Re: PETITION NO. 1312 - Candlewood Solar LLC declaratory ruling that no Certificate of Environmental Compatibility and Public Need is required for the proposed construction, maintenance and operation of a 20 megawatt AC (26.5 megawatt DC) solar photovoltaic electric generating facility located on a 163 acre parcel at 197 Candlewood Mountain Road and associated electrical Interconnection to Eversource Energy's Rocky River Substation on Kent Road in New Milford, Connecticut. **Court Remand on Visibility**

**CANDLEWOOD SOLAR LLC RESPONSES TO
CONNECTICUT SITING COUNCIL
COURT-ORDERED REMAND REGARDING VISIBILITY INTERROGATORIES**

On April 11, 2019 the Connecticut Siting Council (the "Council") issued Interrogatories to Candlewood Solar, LLC on the Court-ordered Remand Regarding Visibility. The following are Candlewood Solar, LLC's responses to the Council's questions included in Interrogatory Set 1 dated April 11, 2019:

FIGURE
 1

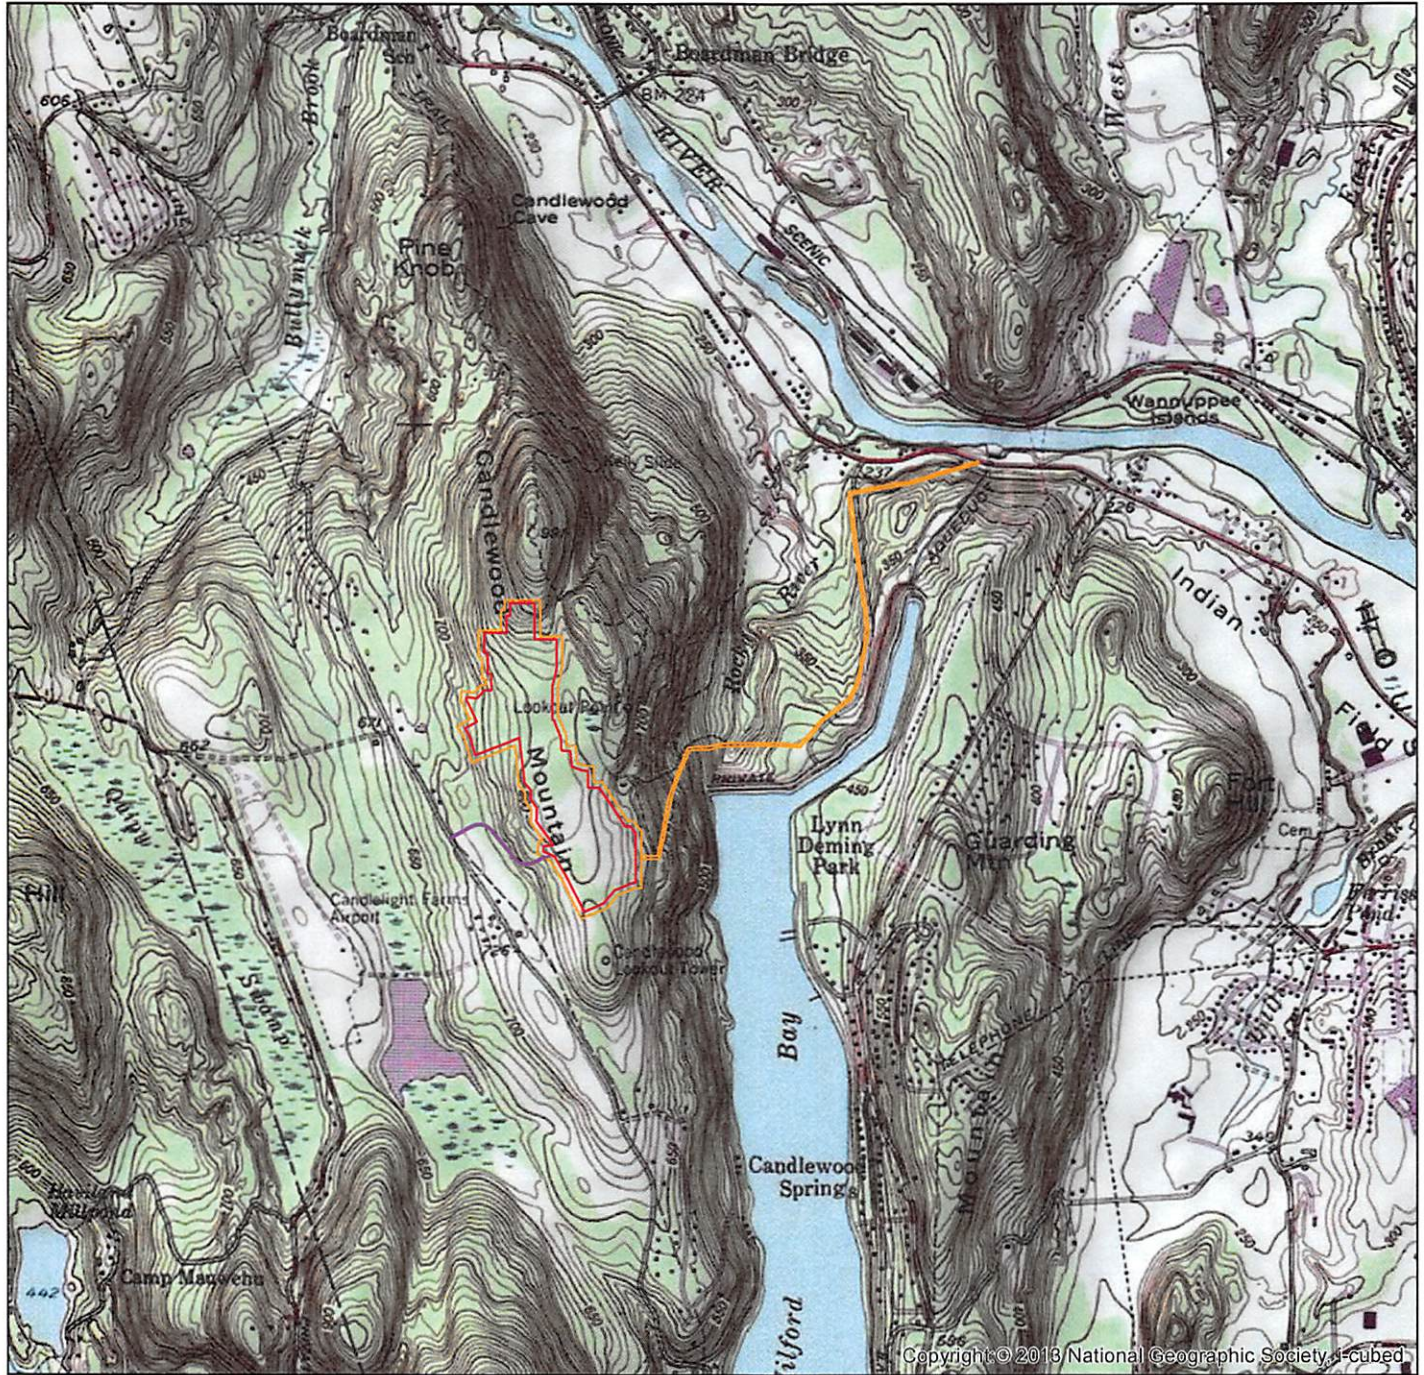
3. Please provide an aerial photograph of the approved solar facility. Superimpose the abutting property boundaries and the limits of work/clearing for the approved solar facility on the aerial photograph.

Identify the abutting property owners on the aerial photograph. Also, on the aerial photograph, indicate the following distances:

- a. The closest distance from the access drive limits of work/clearing to the nearest residential property line;
- b. The closest distance from the access drive limits of work/clearing to the closest corner of the nearest residential structure;
- c. The closest distance from the solar array limits of work/clearing to the nearest residential property line; and
- d. The closest distance from the solar array limits of work/clearing to the closest corner of the nearest residential structure.

Response: An aerial photograph of the approved solar facility with the requested information is included as Figure 1. The distance from the access drive to the nearest residential property line is approximately 20-feet. The distance from the access drive to the nearest residential structure is approximately 160-feet. Along the western boundary, the limit of work ("LOW") line corresponds to the Facility property line on Figure 1, however, the proposed limits of work are being revised to address previous comments related to stormwater management which will result in a minimum 50-foot setback from the property line to the limit of work (discussed further in the response to 6(a)(f) below). The closest distance from the limit of work to the nearest residential structure is approximately 280-feet (guest house at 183 Candlewood Mountain Road).

Response: The closest off-site residence structure (guest house) is located at 183 Candlewood Mountain Road at a distance of approximately 350-feet to the solar array fence (Figure 1). Note that the proposed limits of work are being revised to provide a minimum setback of 50-feet.

FIGURE
3

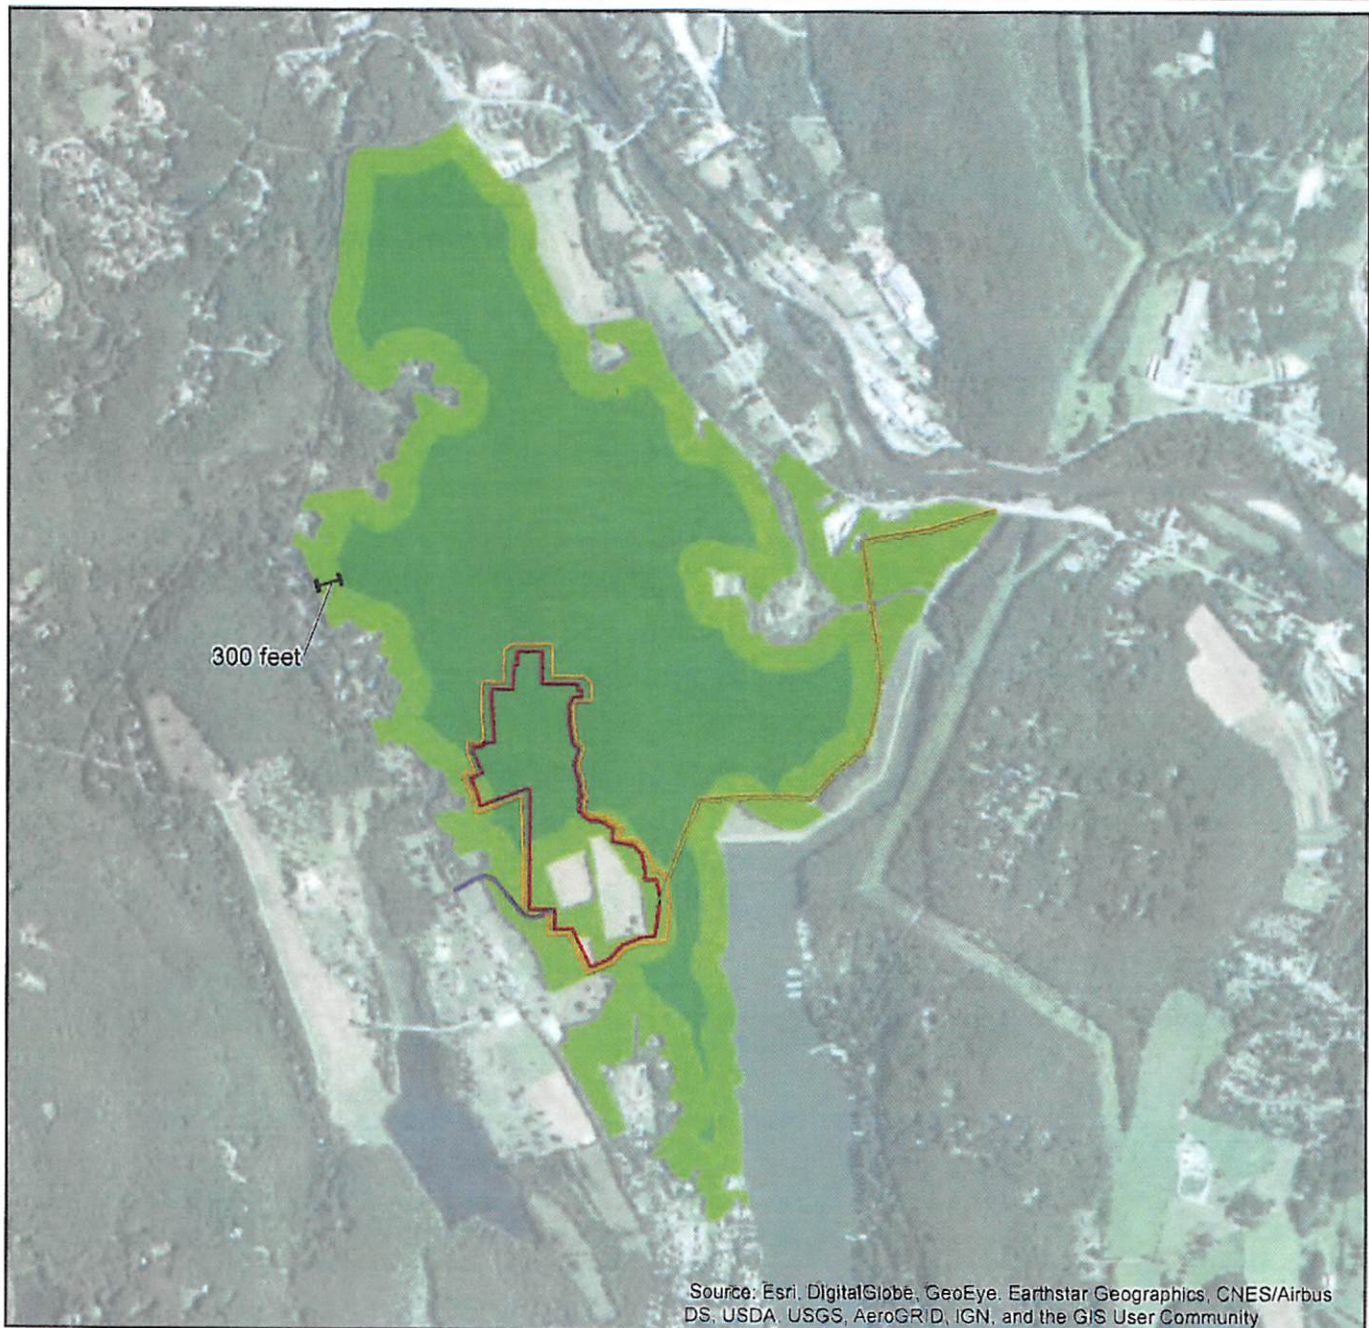
8. Referencing FOF#273, superimpose the limits of work/clearing on a core forest map.

Response: See Response to interrogatory 8 and Figure 3 which is a map depicting the contiguous forest area and how this relates to the approved solar array.

Response: A figure showing the limits of work/clearing superimposed on a map of core forest is included as Figure 3. Note that the limits of work/clearing are being revised as part of the array redesign to address comments on the stormwater management approach.

NEW MILFORD CANDLEWOOD SOLAR - DETAILED SITE PLAN - SOLAR ARRAY
SCALE: 1"=200' WHEN PRINTED 36" x 24"

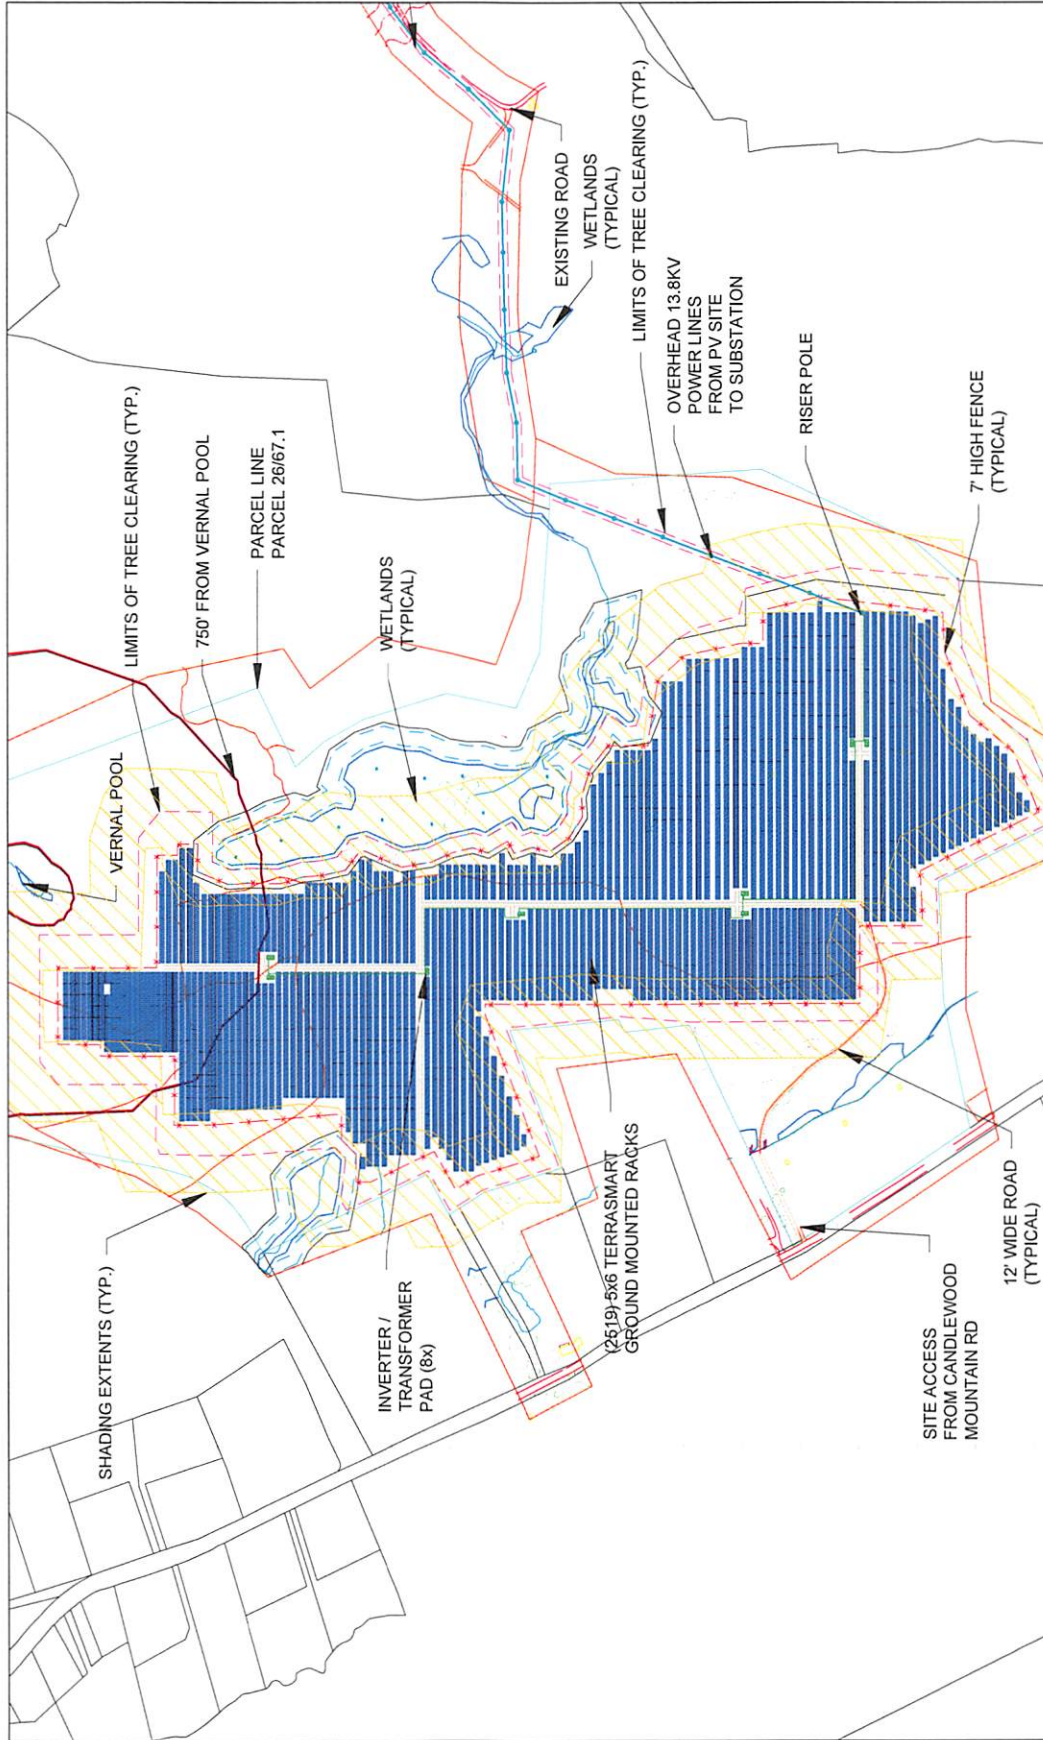
10. Please provide a shade study analysis for the approved solar facility and reconcile such results with the limits of work/clearing between the fence lines of the solar facility and the adjacent property lines. Are the limits of clearing required to reduce shading effects or also for construction purposes? Explain.

Response: A shading analysis figure is included as Attachment D. Clearing is proposed to the R-80 allowed setbacks (see response to 9 above for additional information) and Candlewood Solar accepts

the loss of production due to portions of the array being shaded which is shown in the figure included in Attachment D.
